Delegated Report

Householder Planning Application

Planning Application No: 20231086

Location: 1 Marconi Road Northfleet Gravesend Kent

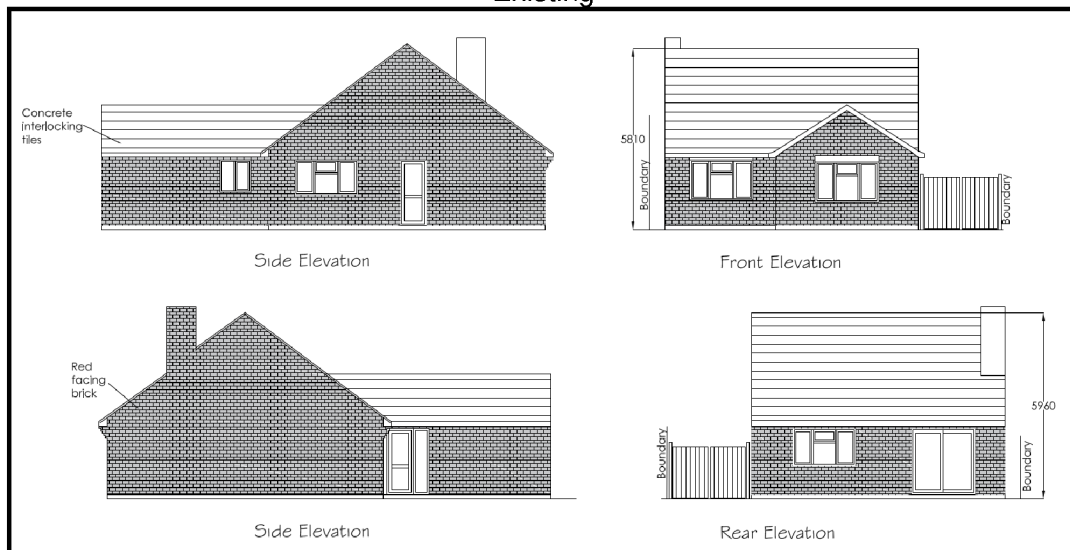
In terms of the above, this new scheme has removed the flat section of roof and introduced a fully pitched roof instead. The previous roof height was 5.81m and the proposed pitched roof here, would have a maximum height of 5.96m, so an increase of 0.15m. However, considering that the proposed pitched roof would have a shallower pitch, it would result in lesser roof volume. This is considered an improvement to the scheme. It is also noted that the previously proposed front dormers have been removed from the scheme and replaced with rooflights instead, which again would be an improvement. Whilst it is unfortunate that the proposed side extension would be close to the neighbouring boundary, closing the side access to the rear garden, at a low height, only 0.15m above the existing bungalow roof height, this would not be significantly harmful to the character of the area. The gaps between the properties in this location vary considerably but are mostly modest as per the example here and so not out of keeping with the wider vicinity.

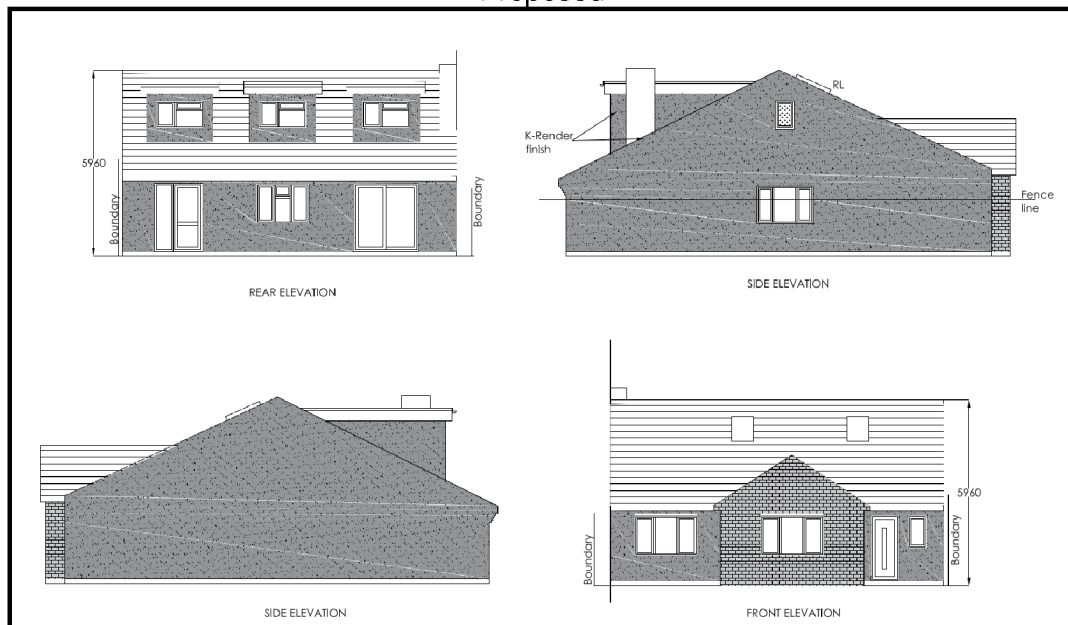
However, assessment should be undertaken as to whether the proposed extensions would overwhelm the host building. The following images (Not to Scale), compare the existing and proposed elevations to demonstrate the change.

As can be seen from the side and front elevations the front and side extensions would visually result in minor extensions. Whilst there would undoubtedly be changes to the original layout and appearance of the main dwellinghouse, these would not be so substantial visually so as to warrant a refusal and the scheme although two storeys in use, would give the appearance of a bungalow, given its pitch and height. The scheme would therefore comply with those matters highlighted above. The proposed materials would be commonly seen in urban residential areas and so would be appropriate in this setting.
